L190-8980626-00-D

ENGINEERING CHANGE REQUEST (ECR)

DRAWING TITLE Ham Isolation Stack Leg Assembly

REVISION: FROM A TO B

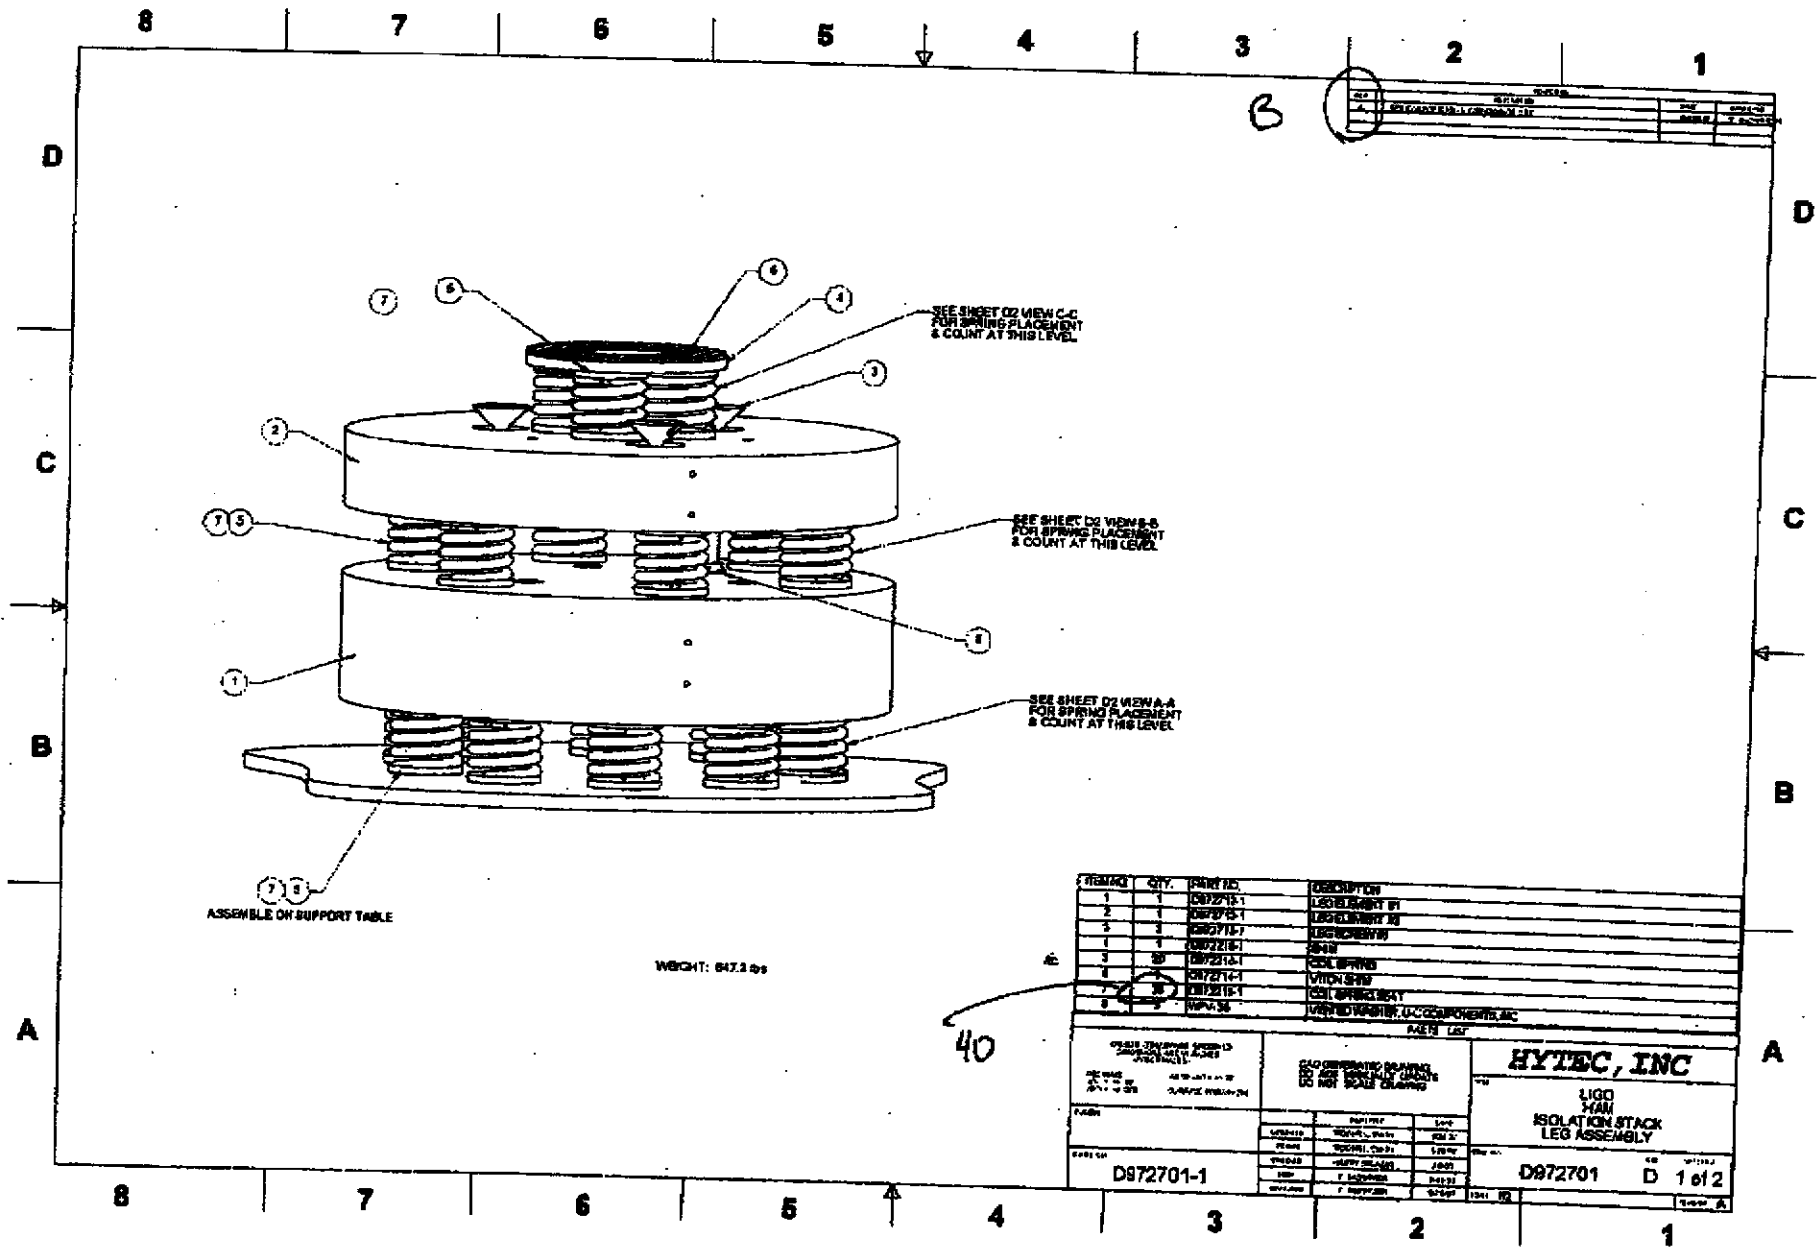
Change reference diameter from 16.9 to 16.5
Item 7 was 38 now 40 (spring seats)
